**U.S. NUCLEAR REGULATORY COMMISSION
REGION IV**

Docket Nos.: 50-313; 50-368
License Nos.: DPR-51; NPF-6
Report No.: 50-313/98-01; 50-368/98-01
Licensee: Entergy Operations, Inc.
Facility: Arkansas Nuclear One, Units 1 and 2
Location: Junction of Hwy. 64W and Hwy. 333 South
Russellville, Arkansas
Dates: January 26 to 30, with in office inspection until March 30, 1998
Team Leader: P. Gage, Senior Reactor Inspector, Maintenance Branch
Inspectors: P. Balmain, Operations Engineer, Office of Nuclear Reactor Regulation

Arkansas Nuclear One, Units 1 and 2 NRC Inspection Report 50-313/98-01; 50-368/98-01

ANO UNIT 1 INTAKE STRUCTURE

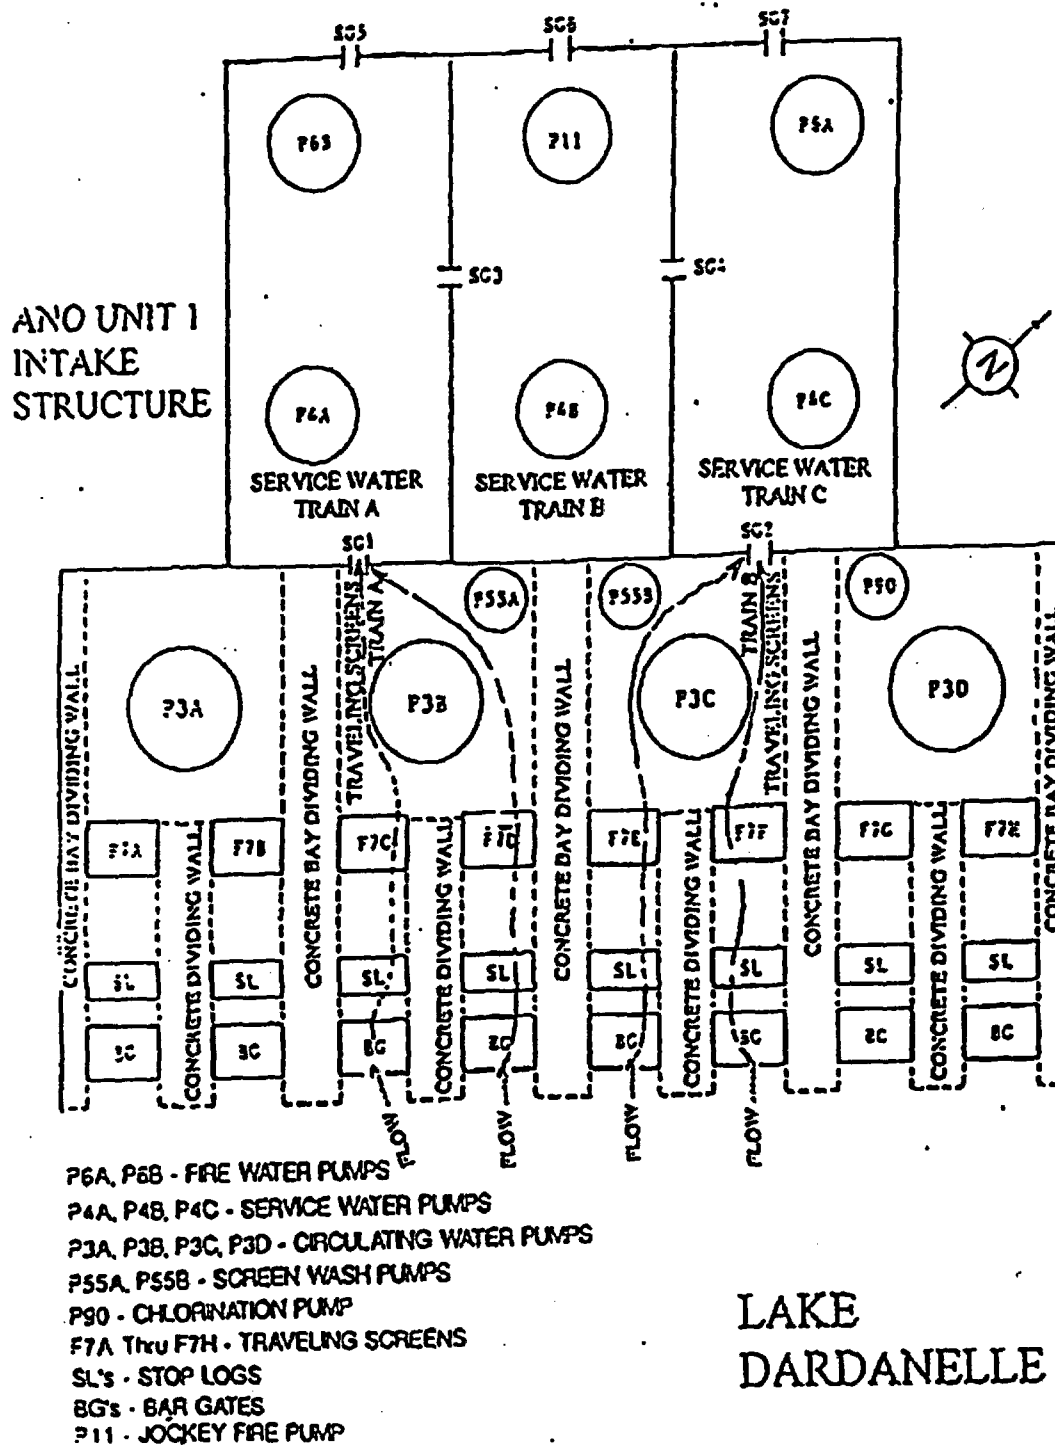
Regarding the traveling screens and screen wash systems, the system engineers provided information that they considered the traveling screens' availability to be tracked under the service water systems. However, since one traveling screen on each unit could provide adequate flow to all the service water loops, any one screen in Unit 2 and any three screens in Unit 1 could be unavailable indefinitely without impacting the availability of the service water loops. Therefore, there was a potential that inadequate performance of the screens could be masked by the overall performance of the service water system.

The team noted that availability was not monitored for some high safety-significant SSCs, specifically, the Unit 2 traveling screens and charging pumps, and the Unit 1 traveling screens. Since availability criteria for these SSCs were not established, balancing reliability and availability could not be achieved. As discussed in Section M1.2, the conditional probability [of success] was used as a performance criteria for some high safety-significant SSCs (e.g., Unit 2 charging pumps). The team questioned the use of the conditional probability [of success] as a performance criteria for balancing reliability and availability because of potential masking of the reliability variable by the availability variable. For example, reliability could increase due to improvements in design or environmental conditions, and availability could decrease due to scheduling more preventive maintenance, which counteracts the effects of increasing reliability in the conditional probability formula. Since the product combination of the

In response to the inspector's concerns, an enhancement was implemented to add performance criteria and monitoring of Unit 1 lake source paths availability. This criteria has been added to the Unit 1 Traveling Screen system and improves availability monitoring of the complete path from the lake to the service water sluice gates. The additional monitoring is beneficial in that any impact to lake availability resulting from traveling screen corrective maintenance, bay outages for zebra mussel cleaning, circulating water pump maintenance, and circulating water bay maintenance activities will be monitored. In addition, monitoring both paths (basically at a train level) results in a criteria that is more predictive in nature and further ensures that masking and shadowing does not occur. The Traveling Screen system technical basis document and the maintenance rule data base has been updated to reflect the new performance criteria.
